Proposed Revisions to a Standard Plans Index

Index Number: 700-110

Index Title: Mounting Exit Number Panels to Signs

Summary of the changes:

| LAST REVISION | DESCRIPTION: |  FY 2022-23 STANDARD PLANS | MOUNTING EXIT NUMBER PANELS TO SIGNS | INDEX 700-110 | SHEET 1 of 1 |

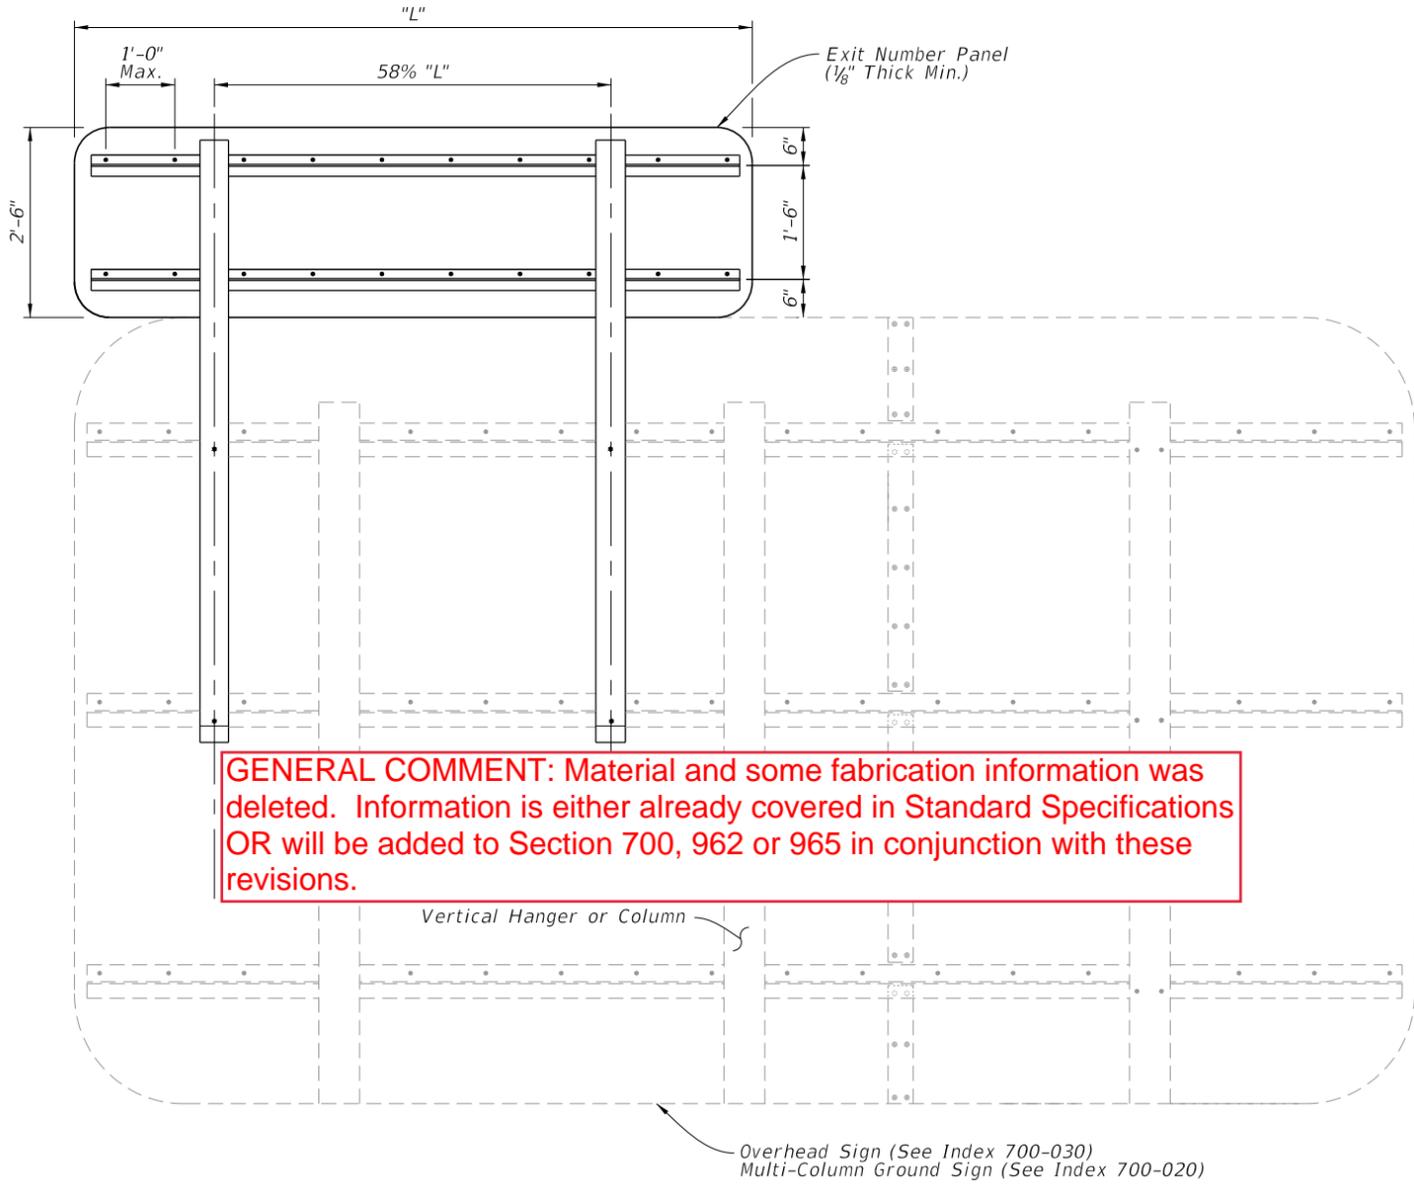
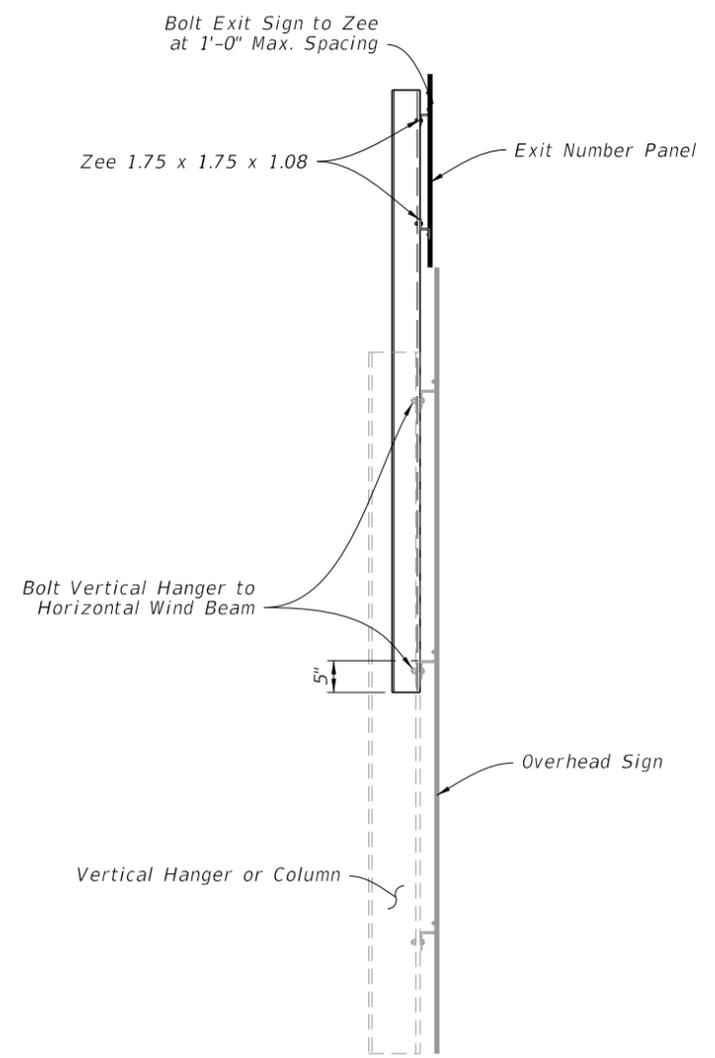
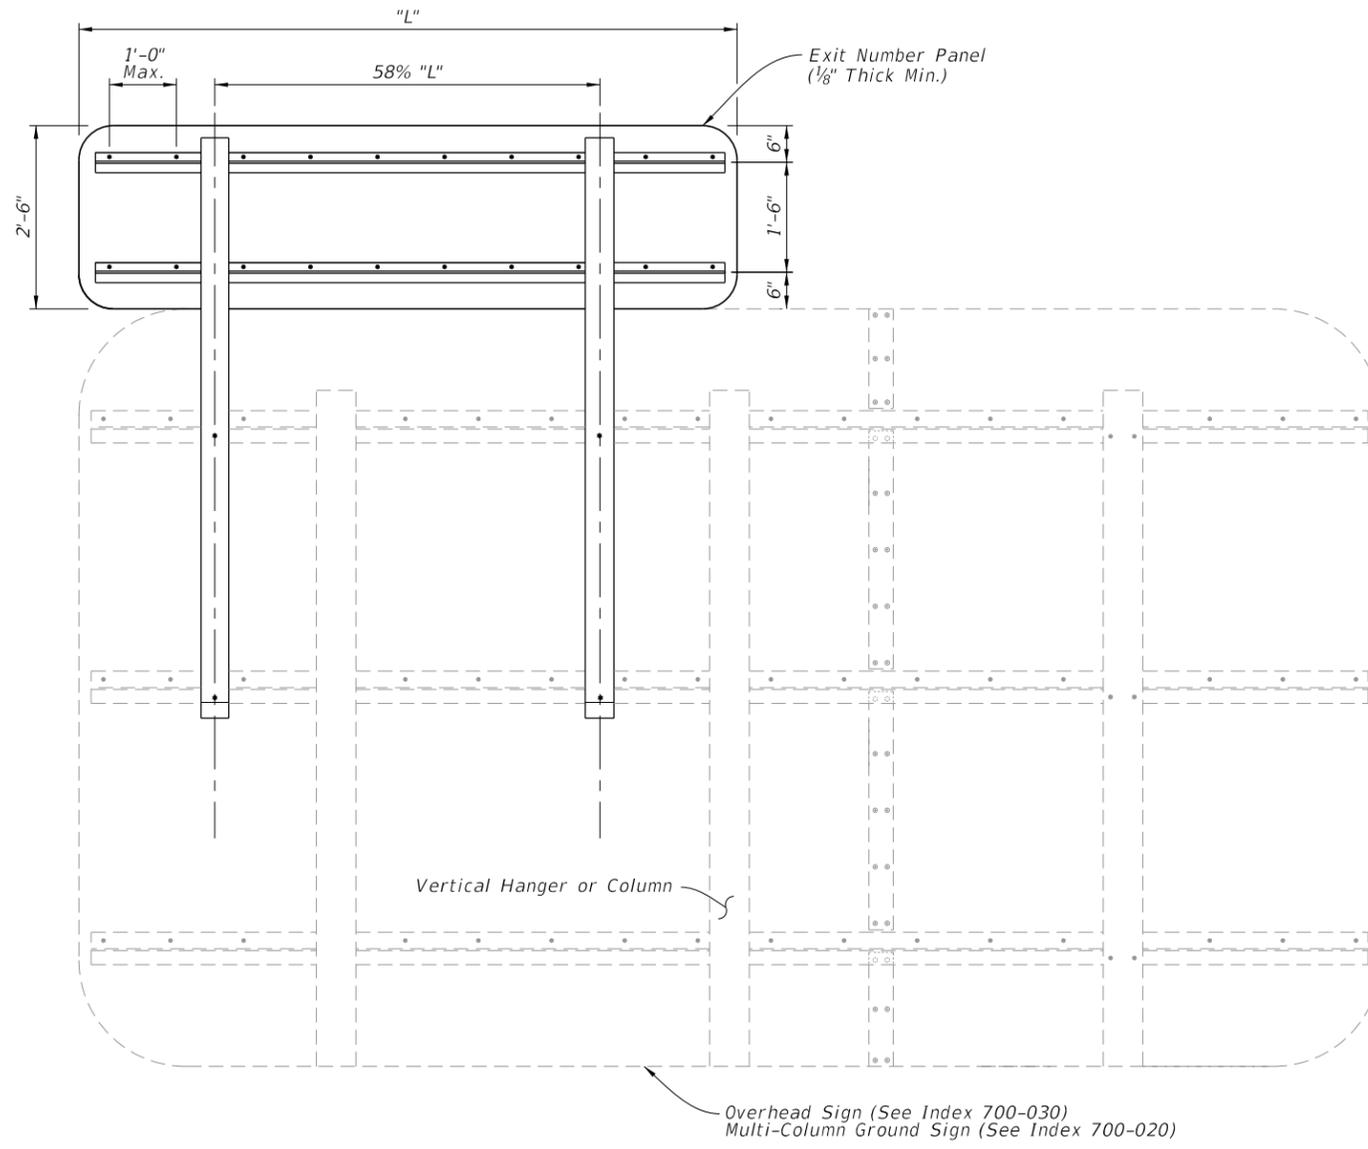
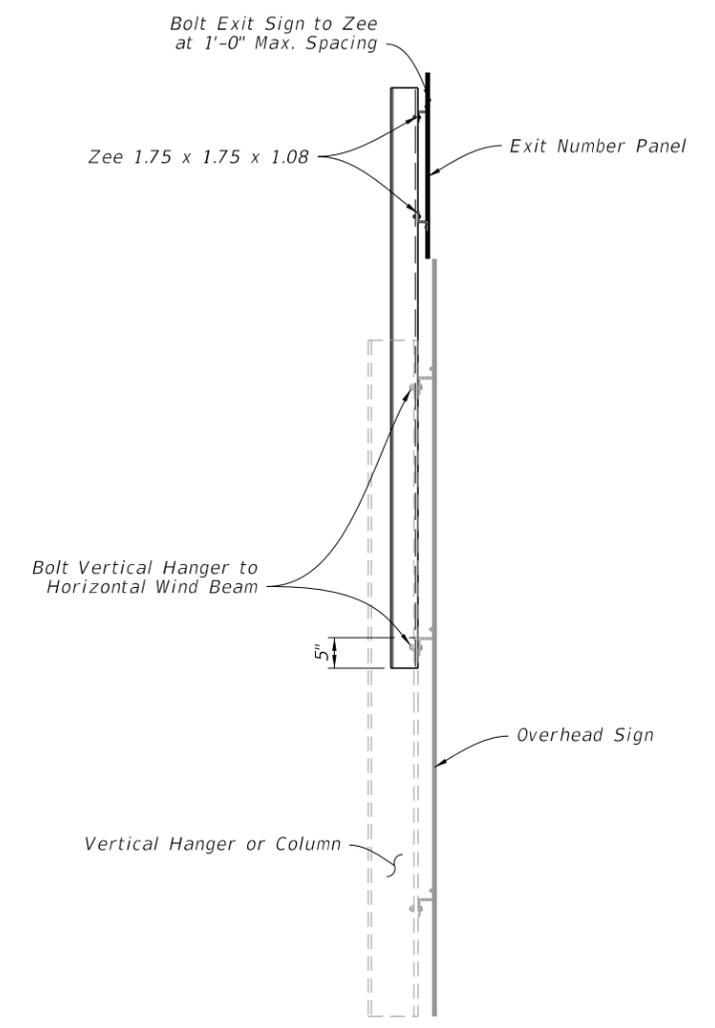
Updated Notes to General Notes; Added New General Note 1 - "Meet the requirements of Specification 700."; Deleted Note 2 and 3.B.; Renumbered General Notes.

ADDED NEW NOTE 1: Meet the requirements of Specification 700.

1. ~~NOTES:~~ **UPDATED: GENERAL NOTES:**

2. ~~1. Work with Indexes 700-020 and 700-030.~~
- ~~2. Materials (Aluminum):~~
- ~~A. Sheets and Plates: ASTM B209 Alloy 6061-T6~~
 - ~~B. Standard Structural Shapes: ASTM B221 Alloy 6061-T6~~
 - ~~C. Extruded Shapes: ASTM B221 Alloy 6061-T6~~
 - ~~D. For Bolts, Nuts, and Washers requirements see Index 700-020 or 700-030.~~
- ~~3. Fabrication:~~
- ~~A. See sign layout sheet for dimension "L" and sign face details in the Plans.~~
 - ~~B. Round all sign corners.~~
4. For right exits, install the Exit Numbering Panel to the top right side of the Highway Sign.
5. For left exits, install the Exit Numbering Panel to the top left side of the Highway Sign.

1. Meet the requirements of Specification 700.
2. Work with Indexes 700-020 and 700-030.
3. Fabrication:
See sign layout sheet for dimension "L" and sign face details in the Plans.
4. For right exits, install the Exit Numbering Panel to the top right side of the Highway Sign.
5. For left exits, install the Exit Numbering Panel to the top left side of the Highway Sign.
